**Subject:** 20-DDP-0045 Providence Point Apartments

#### COMMENTS TO 20-DDP-0045 Plan 110620 HAGAN PROPERTIES PROPOSAL TO DEVELOP 520 PROVIDENCE POINT APARTMENTS ON HERR LANE

#### COMMENTS TO 20-DDP-0045 Plan 121420 HAGAN PROPERTIES PROPOSAL TO DEVELOP 520 PROVIDENCE POINT APARTMENTS ON HERR LANE

# COMMENTS TO 20-DDP-0045 Plan 121420 HAGAN PROPERTIES PROPOSAL TO DEVELOP 520 PROVIDENCE POINT APARTMENTS ON HERR LANE

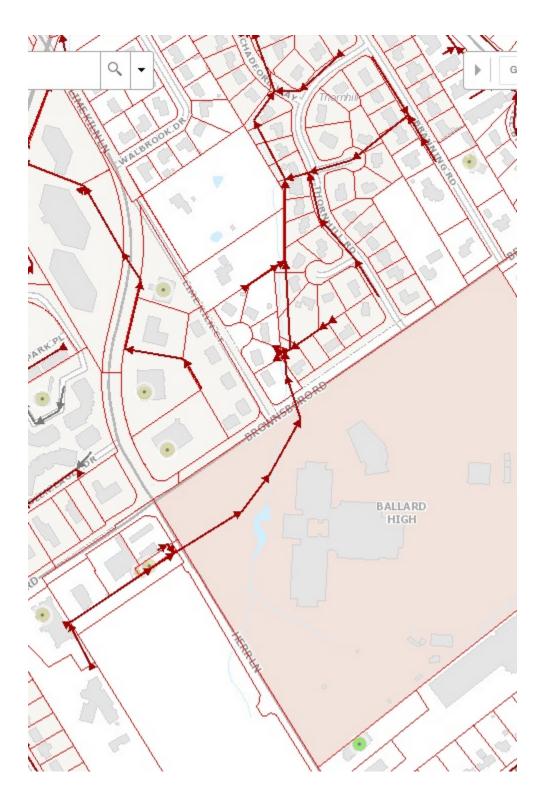
I have downloaded the APO affected property owner list from P&D and it had just a single City of Thornhill resident on the Notice List. Please add all the City of Thornhill residents to the APO list. The above site map from the Herr Lane Traffic Corridor Study shows the blue line stream of drainage flowing under Rt 22 and into City of Thronhill. The drainage from the Proposed Providence Point Apartments as shown on the development Plan would be disposed of without detention onto the JCPS property, and from there into Thornhill Creek and the City of Thornhill.

Fig.1 - 212 acres watershed map. Heritage Engineering LLC 2012.

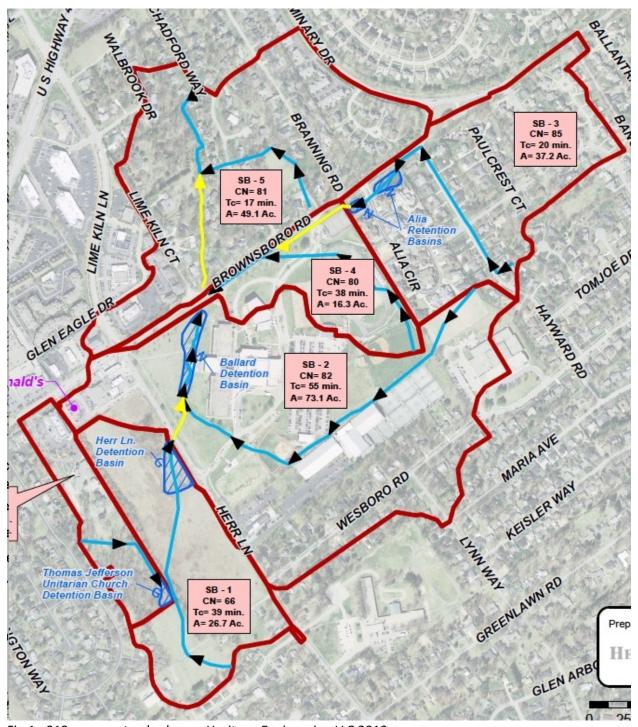
"This RDDDP contemplates that storm water will be accommodated by virtue of an expanded MSD regional basin, instead of one on site, on the Ballard High School property which this developer will help finance."

Subsequently, in the 121420 revised Plan the Applicant sought DDP approval without specifying whether storm water management would be through expanding the Ballard Basin, or by constructing on-site, underground storage of some 3.8 acre-feet.

Fig. 5 Floodwall built by MSD with Mr. Dolans property on right -unprotected at the 563.5 crest elev.

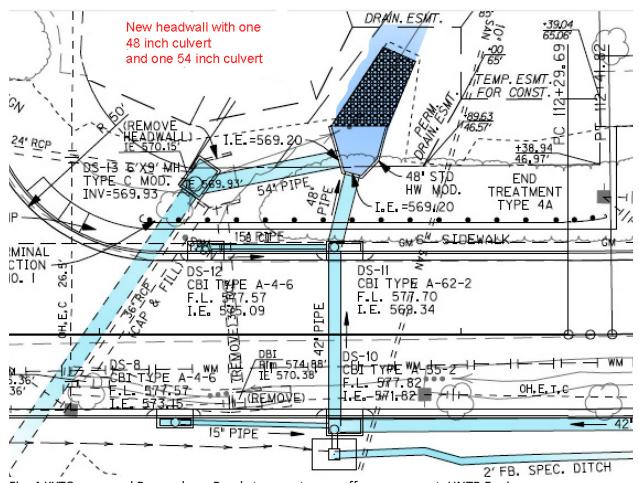
MSD promised and constructed, at a cost of about \$ 250,000, in the stream bed a monolithic concrete floodwall for the protection of a single property. See Floodwall Fig. 5.

Fig. 8. Heritage Engineering Report 2012 Analysis of Flooding in City of Thornhill. (annotated) Hydrographs of the 100 year 24 hour storm at Chadford Way -existing and Scenario 9.

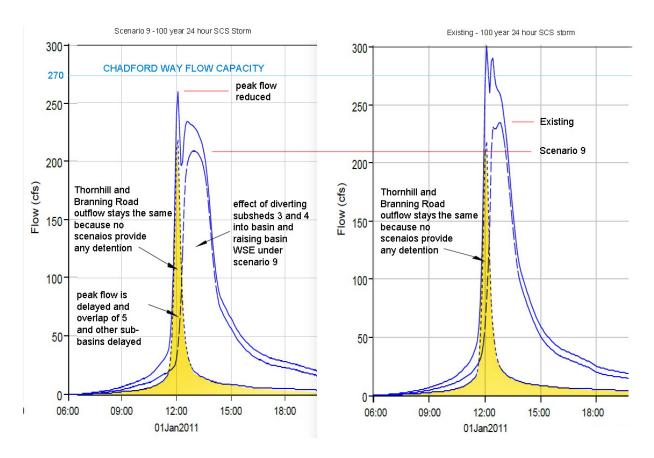
Flooding at Chadford Way occurs when peak runoff from sub-basin 5 overlaps with runoff from sub-basins 3, 4 and early flow from the Ballard basin from the school and parking areas.

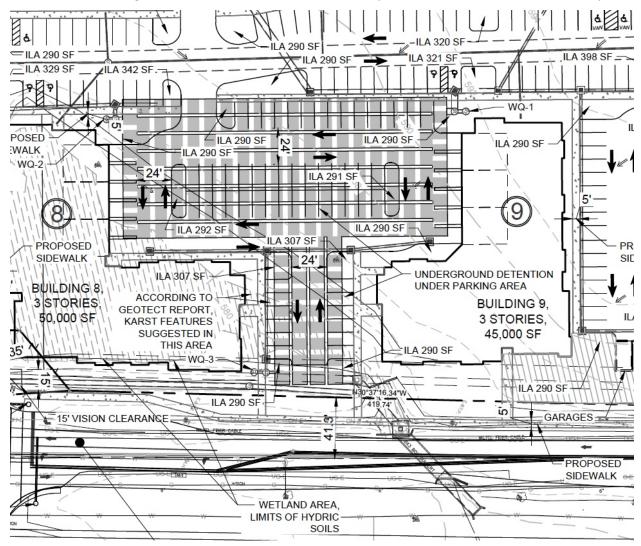
Storm events exceeding the design storm can overtop the planned 3.8 acre feet of storage and contribute to flooding downstream. No outlet structure or its performance is shown in the revised plan.

The underground detention outlet structure performance must be modeled for storms in excess of the design storm. Once detention is filled, the 19 acres of impervious will accelerate peak flows from 40 acres into the Ballard basin. The other 20 acres of properties west of Providence Point drain through Providence Point. Previous Heritage Engineering LLC modeling showed the Ballard Basin was briefly overtopped in the September 2006 flooding event. That event exceeded the design storm intensity. The Providence Point storm water management plan has to be designed to prevent overtopping the dam and risking a dam breach in a 2006 type event.
